**White Rose Development Plan Amendment
Production Volume Increase
Supplemental Information**

Husky Document No. WR-DVG-RP-0010

Following submission of the Development Plan Amendment, the C-NLOPB conducted a Completeness Review and on October 26, 2006 issued a request for additional information (C-NLOPB File:8010) (Husky Reference No. 003979508). This supplemental report addresses the request for additional information received from the C-NLOPB.

Figure 1 Velocity Concern Imposed on the Crude Lines Operating at 140, 000 bbl/d (22,261 m³/d)

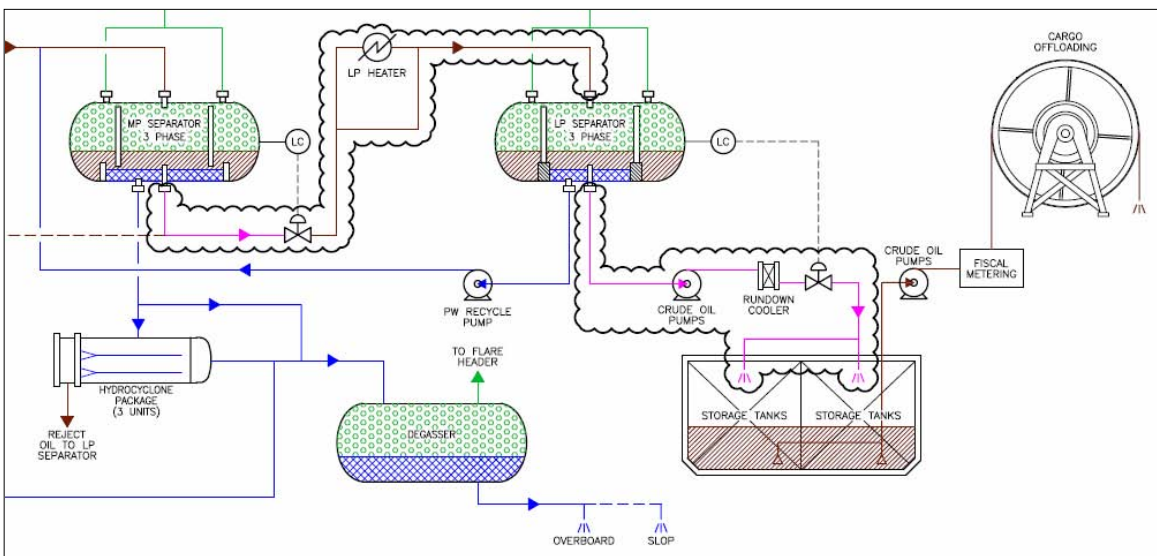
With the increased production scenario a number of Crude Oil lines that exceed API recommended velocity criteria have been identified. These are further detailed in Appendix A. While the velocity in the crude oil lines exceeds the API criteria, the velocities remain within the NORSOK guidelines. The exception to meeting the NORSOK criteria is the crude oil cooler bypass, however this is not open in the normal operating case and will only be fully open in the event of a process upset.

For each of the lines between the LP Separator and the cargo tanks the increased velocity corresponding to 140,000 bbl/d (22,261 m³/d) was calculated and evaluated against the original design philosophy. Current design data was extracted from the linelist WR-P-30-B-SC-00001 rev Z1 and prorated from the current 100,000 bbl/d (15,900 m³/d) to 140,000 bbl/d (22,261 m³/d), with the exception of the cargo tank lines, whose maximum flowrate was extracted from the P&ID. The limits of the investigation are clouded in Figure 1, with the lines exceeding the velocity requirement highlighted in magenta (ref. Calculation 1A007-006). The lines that exceed the API RP14E velocity criteria are also tabulated in Table 1.

These velocities occur under normal conditions. Operating of control valves will typically increase flow rate by 20 to 40%. The lines highlighted in Table 1 require further investigation because the high velocities introduce the potential for vibration-induced fatigue and erosion to occur. Specifically, a risk review will be completed followed by development of a crude rundown lines inspection plan and subsequent erosion inspections on the affected lines.
